Product Service Group CE Audio

Service Information

CORRECTION TO SERVICE MANUAL

CHANGES DURING PRODUCTION

MMPWR 100W MODULE - MAINS BOARD

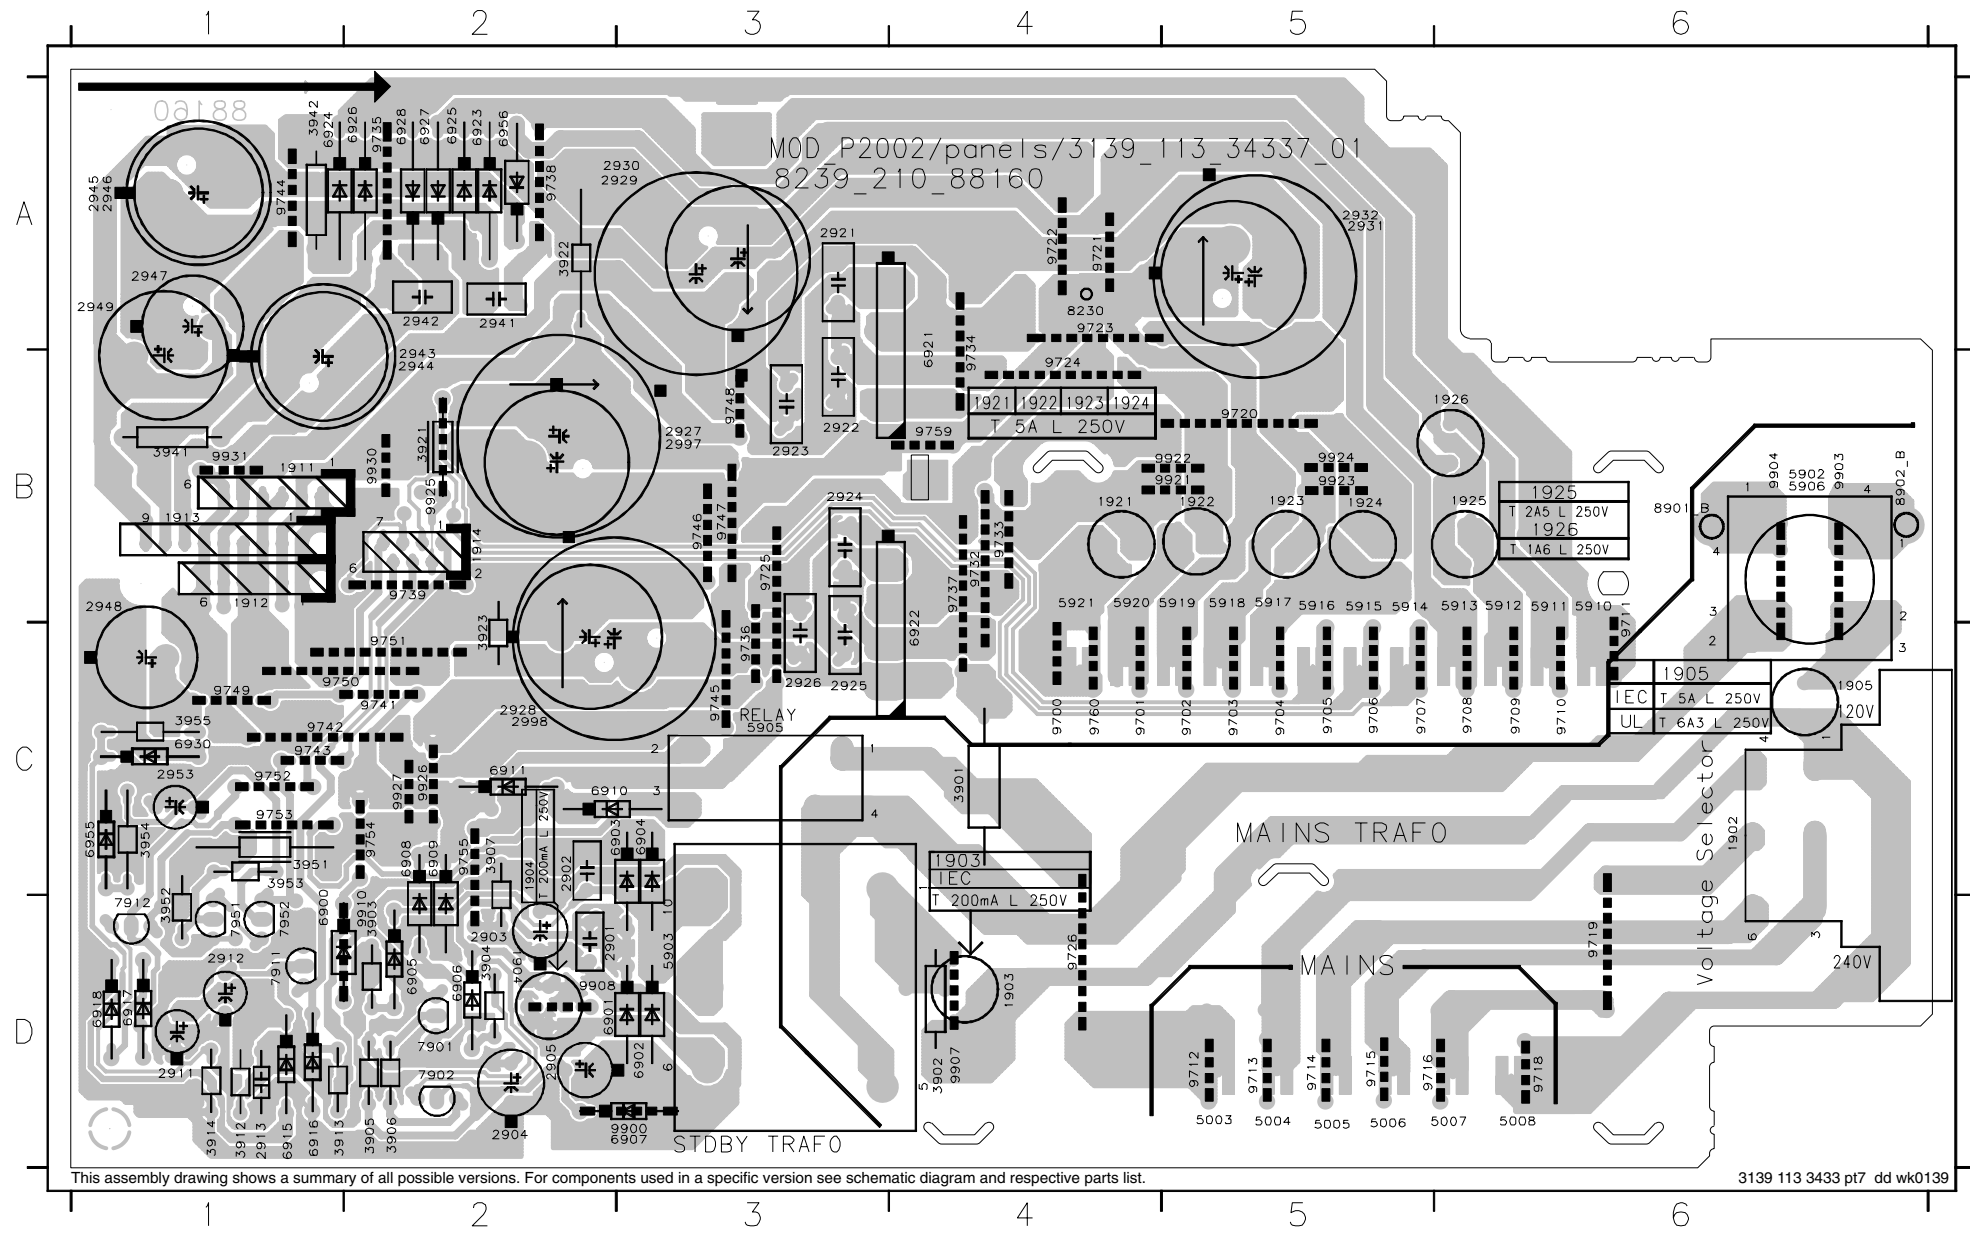
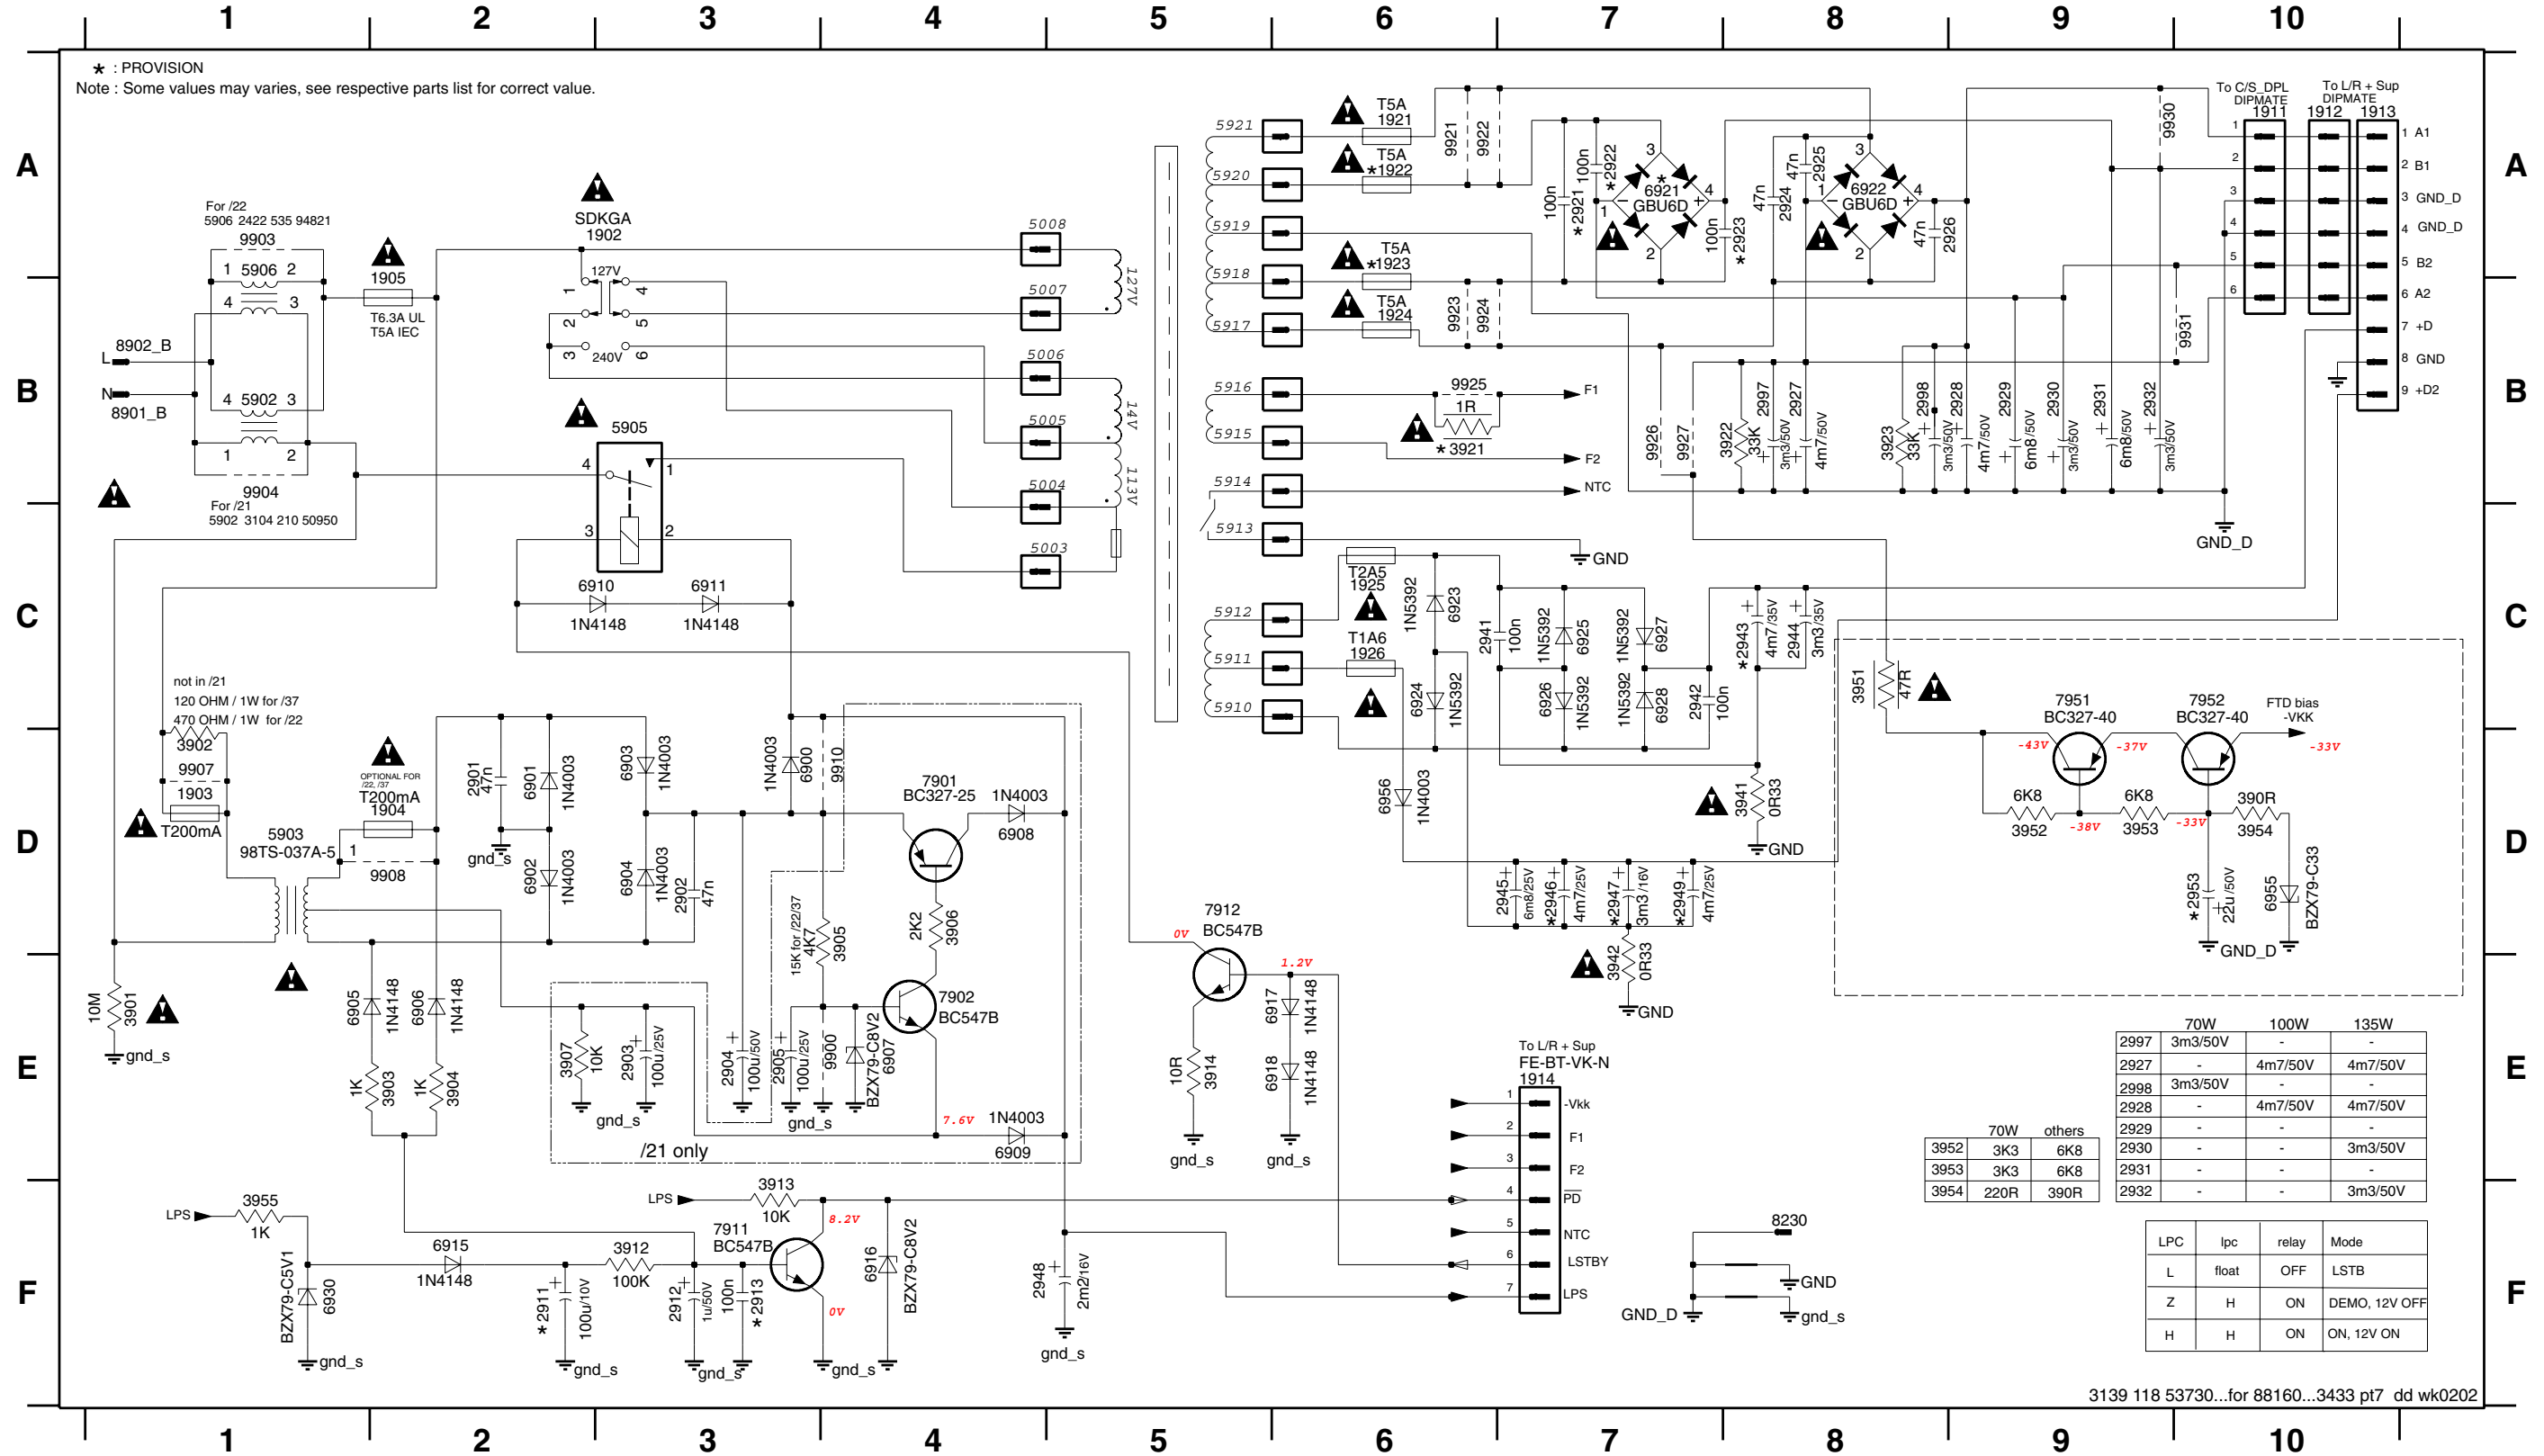
*During production pt.7 Board (identified by the last digit of the 12NC - 3139 113 34337) is introduced. For this reason new layout and circuit drawing are enclosed.
